New Albany Architectural Review Board
Monday, February 09, 2026 Meeting Minutes - Approved

ZC-80-2025 Fire Station COA

**PLAIN TOWNSHIP FIRE STATION
CERTIFICATE OF APPROPRIATENESS**

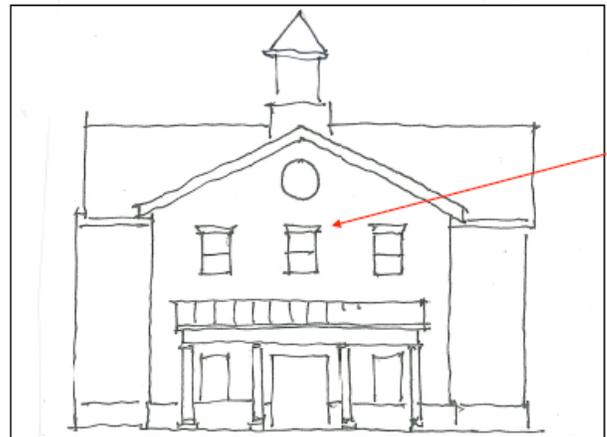
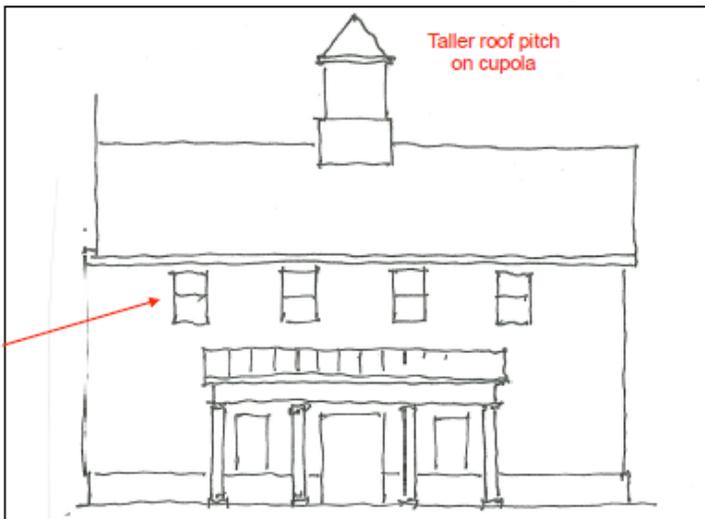
- The two-story gable at the main entry appears inconsistent with the overall front façade. The City Architect recommends removing the gable and redistributing the windows to achieve a more balanced and cohesive design. If the gable is retained, a centered second-story window will be required, as illustrated below.

- Provide a taller roof pitch on cupola.

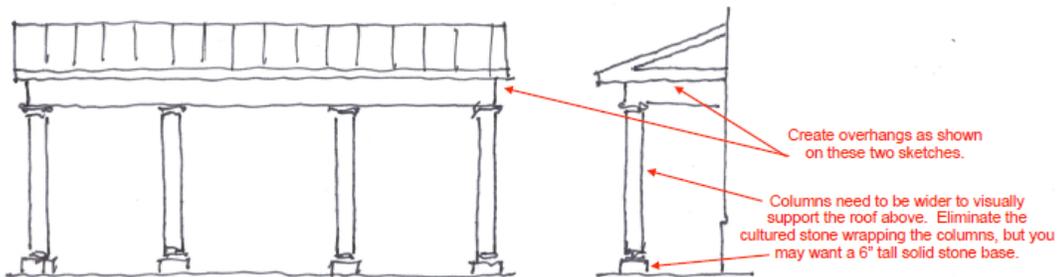
- Create overhangs as shown on the sketch below
- Columns should be wider to visually support the roof above. Eliminate cultured stone wrapping the columns and use a 6' tall solid stone base.
- Align neck of columns.
